Stakeholder Comment Request – Draft Market Rules and Market Manuals

MR-00439-R00-05 – Transitional Capacity Auction

<p>Date Submitted: <i>June 4, 2019</i></p> <p>Feedback Due: June 5, 2019</p>	<p>Feedback provided by:</p> <p>Company Name: Ontario Power Generation</p> <p>Contact Name: Jin Kim</p> <p>Phone: [REDACTED]</p> <p>Email: [REDACTED]</p>
--	--

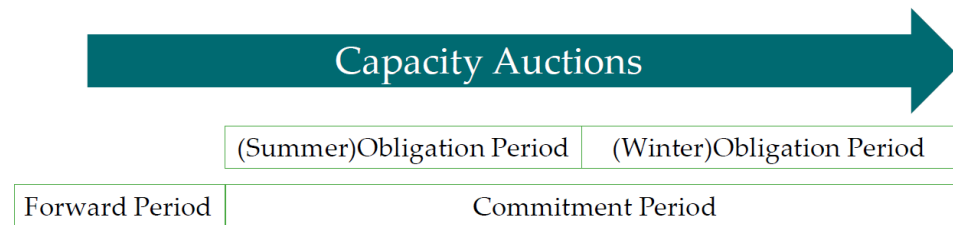
- It appears that Figure 3-3, which illustrates the commitment and forward period, has been removed. To make things clear for Market Participants, please consider using the Capacity Auction timeline figure from Page 22 of the "Transitional Capacity Auction Draft Phase 1 Design" presentation dated May 22, 2019 (see image below)
